HENDERSON COUNTY TECHNICAL REVIEW COMMITTEE

SUBJECT: Revised Master Plan for The Sanctuary (Horse Shoe Farm Property)
(2017-M01) (December 2017 Revised Master Plan)

Henderson County Planning Department Staff Report

**Revised Master Plan
The Sanctuary at Eagles Nest-Horseshoe Farm (2017-M01)**

MASTER PLAN

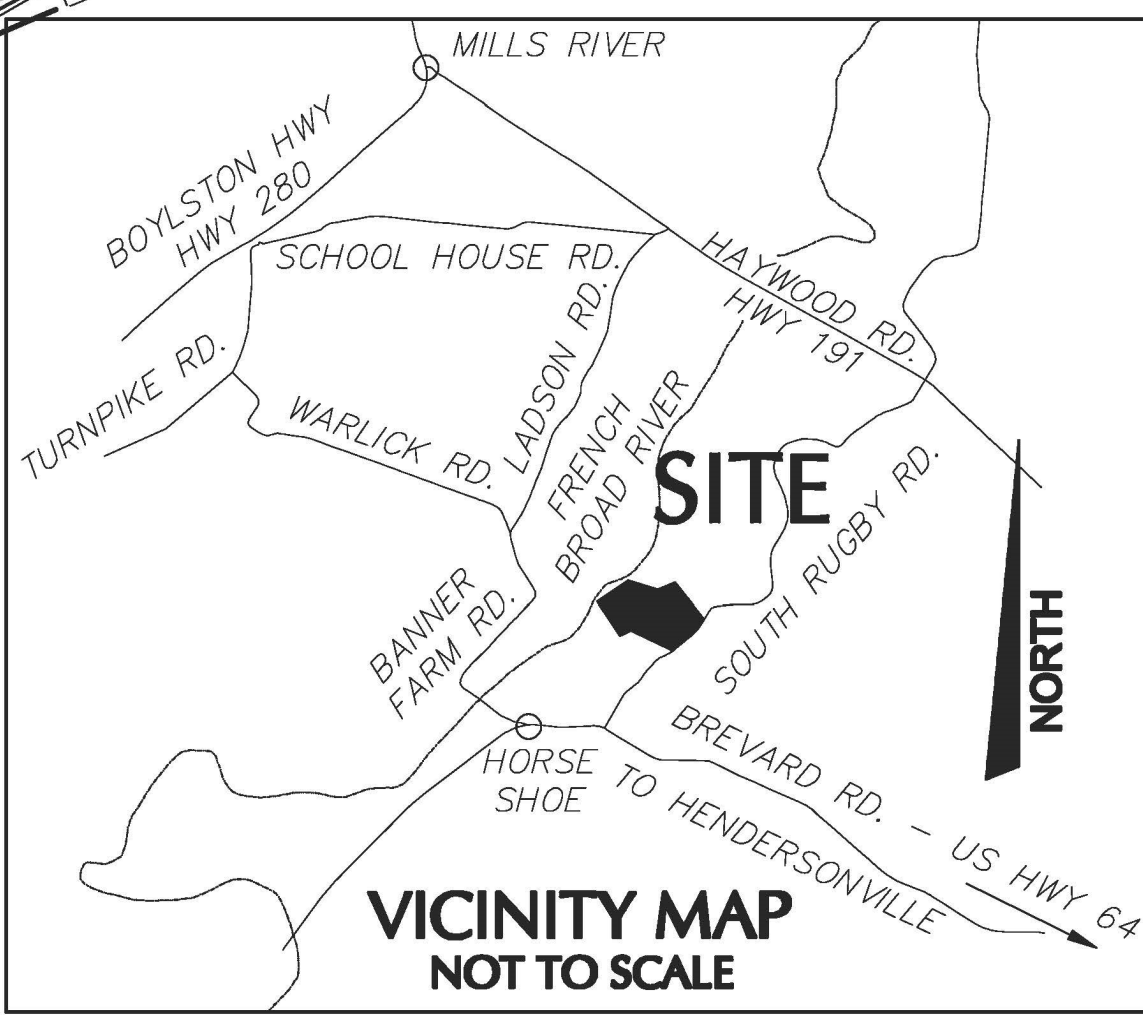
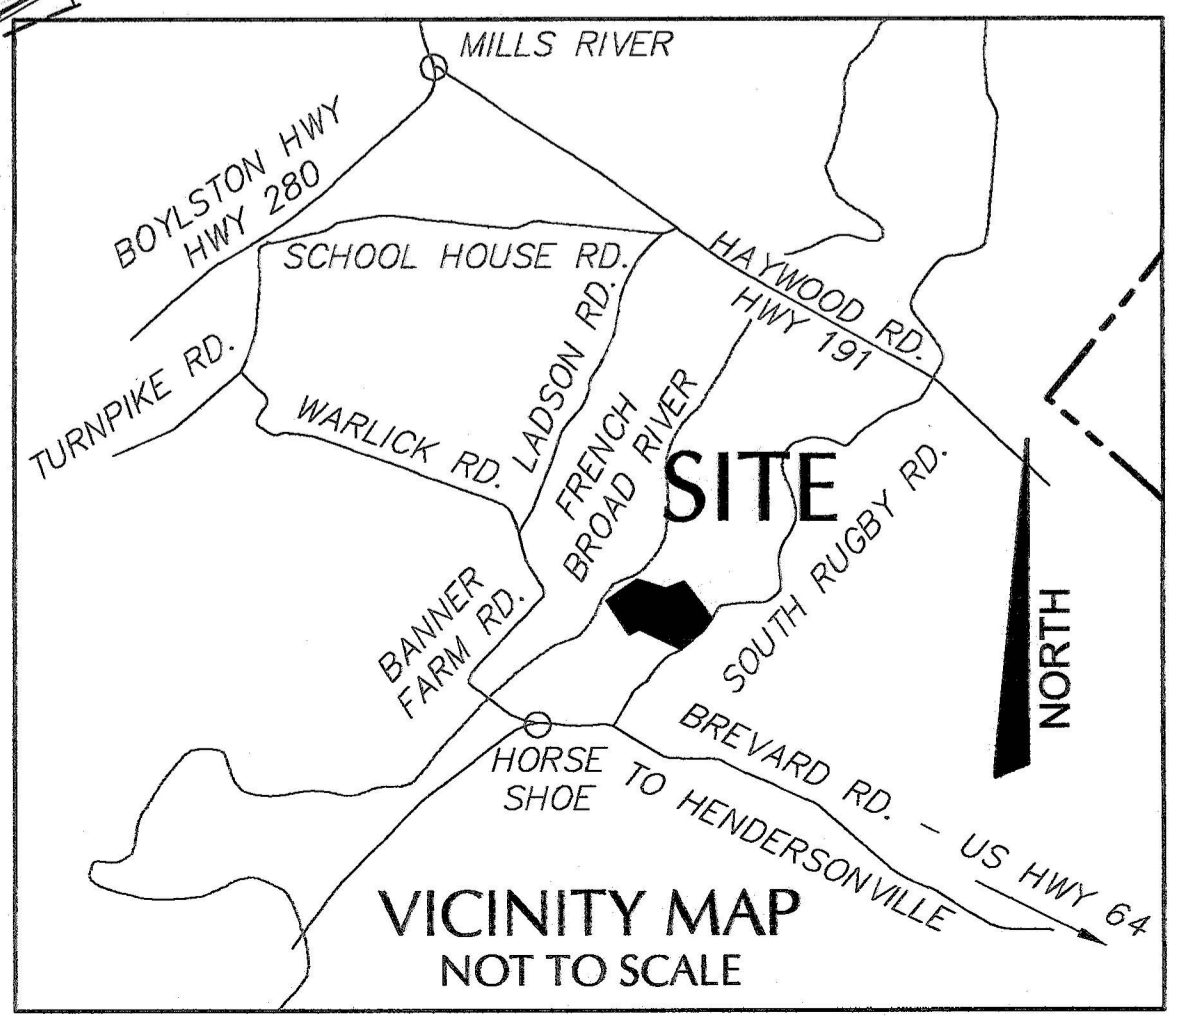
**Changes from approved plan from February 2017 are highlighted

Approved	Revised
Total Acreage: 85.31	Total Acreage: 85.31
Project Acreage: 85.31	Project Acreage: 80.8
Outparcels: 0	Outparcels: 3
198 Dwelling Units	132 Dwelling Units/Lots
116 Duplex Units (58 Structures)	74 Duplex Units (37 Structures)
81 Triplex Units (27 Structures)	51 Triplex Units (17 Structures)
1 Guest Unit Over Barn	1 Guest Unit Over Barn
0 Single Family Dwellings	3 Single Family Dwelling-2 with 1 ac. lots
Density: 2.32 Units/Ac.	Density: 1.55 Units/Ac.
394 Residential Parking Spaces	264 Residential Parking Spaces
96 Commercial Parking Spaces	96 Commercial Parking Spaces
69.3% Open Space	69.6% Open Space

3. **Private Road Standards.** The Applicant has indicated an addition or reconfiguration for two roads under this development plan. All subdivision roads must be designed and constructed to the minimum standards of LDC §42A-81 C (Table 3.1). The final plat(s) must contain a note stating: *The private roads indicated on this final plat may not meet the requirements of the North Carolina Department of Transportation for acceptance into the state road system.* Planning Staff proposes the following conditions to ensure the private roads meet the standards of the Land Development Code:

- e. **Dead Ends, Cul-de-sacs and Turnarounds.** The Applicant proposes one (2) cul-de-sacs or turnarounds located at the end of a local road. All turnarounds must meet of the LDC §42A-105 C(8).

4. **Road Name Approval.** Proposed road names for a private and/or public road shall be preapproved by Henderson County in accordance with Chapter 42 of the Henderson County Code, Property Addressing (LDC §42-98). The applicant lists the proposed road names for most road segments. The names of the shared drives should be confirmed with the development plan approval.

5. **Street Tree Requirements.** According to the street tree requirements of Chapter 42 (LDC §42-145 and LDC §42-146) the applicant must provide one tree per 50 linear feet of property abutting an internal road. Trees may be placed in groups with a minimum spacing of no less than 15 feet and a maximum spacing of no more than 65 feet. The trees may be placed within the right-of-way or within 20 feet of the edge of the right-of-way. The applicant may use existing trees in accordance with LDC §42-153 instead of planting new trees. These existing trees must also be located within the right-of-way or 20 feet off the edge of the right-of-way as required by LDC §42-146

6. **Pedestrian Access.** Sidewalks or walking trails are required for any major subdivision of 10 or more lots outlined in Henderson County Code Chapter 42 (LDC §42-113). Reasonable pedestrian access shall be provided to promote healthy and safe walking when a developer proposes a density equal to or greater than two (2) units per acre. The applicant must provide one (1) linear foot of sidewalk or walking trail for every linear foot of improved or newly proposed roadway within the tract. Sidewalks or walking trails are to be located in a road right-of-way, pedestrian access to easement, or other dedicated open space. Sidewalks are to be constructed at a minimum of 5 feet in width using concrete, asphalt, or other permanent all-weather surface such as gravel.

10. **Public Utilities.** City of Hendersonville water currently serves the project site. Extensions of public water are proposed to serve the project. According to the LDC, the applicant must provide evidence that the water supply plans have been approved by the appropriate agency. The development plan may be approved contingent on final approval from such agency; however, the final plat shall not be approved until all such final approvals have been obtained. Any subdivision served by a public water system shall meet the respective county or municipality's minimum requirements for fire hydrant installation.

14. **Fire Protection Requirements.** Any subdivision served by a public water system shall meet the County's standard of one (1) hydrant per 1000 feet of linear road distance. (LDC §42A-81 B(4))

15. **Sewer.** The applicant is proposing an on-site drip system to treat sewage. A state permit for this system is required for future development plan approvals.
